Town of Duanesburg  
Zoning Board Minutes  
June 21<sup>st</sup>, 2022  
**Final Copy**

**TOWN OF DUANESBURG ZONING BOARD OF APPEALS  
RESOLUTION ISSUING INTERPRETATION OR IN THE ALTERNATIVE  
APPROVING AN AREA VARIANCE TO ALLOW EIGHT FEET TALL FENCES  
AT THE OAK HILL SOLAR PROJECTS**

Re: Public Hearing Oak Hill Solar 1, LLC and Oak Hill Solar 2, LLC fence height variance

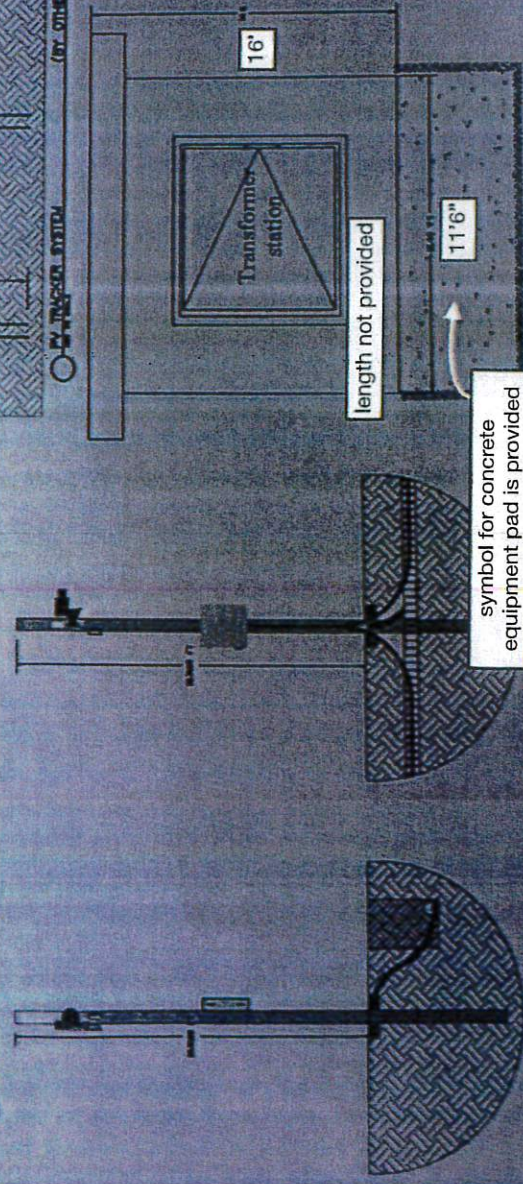
- DETAILS NOT PROVIDED
- Battery Energy Storage
  - Equipment Pads
  - HVAC
  - Control Gear
  - Switchgear
  - Tracking Motor
  - Tracking Gear Assembly
  - Tracking Wiring Harness

symbol for concrete  
equipment pad is provided
